177/18 ENU 5717

# Symptom in Vehicle Interior - Closing Aid for Front Doors Does Not Work at Cold Temperatures (I-no. GZ2): Fitting additional foam part (SY 177/18)

Model Line: Panamera (971)

Trim holder

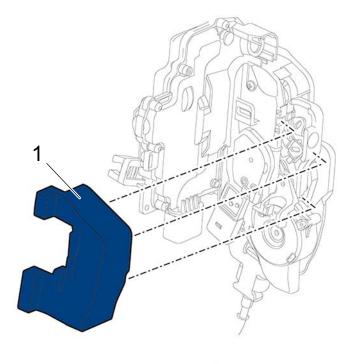
- 1.4 Remove trim holder  $(\Rightarrow Trim holder 1 -)$ .
  - 1.4.1 Pull holder in ⇒ Trim holder -direction of arrow- so that the clips (⇒ Trim holder -2-) loosen. At the same time, try to lift the holder away from the door lock slightly.
  - 1.4.2 Loosen clip (*⇒ Trim holder* -3-) and remove holder.

Foam part

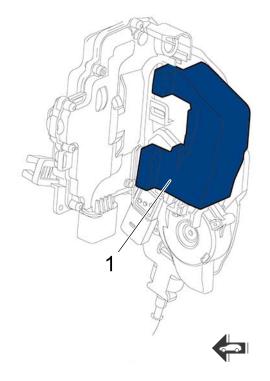
- 2.1 Pull film off adhesive strips on the foam part.
- 2.2 Secure the foam part on the door lock as shown.
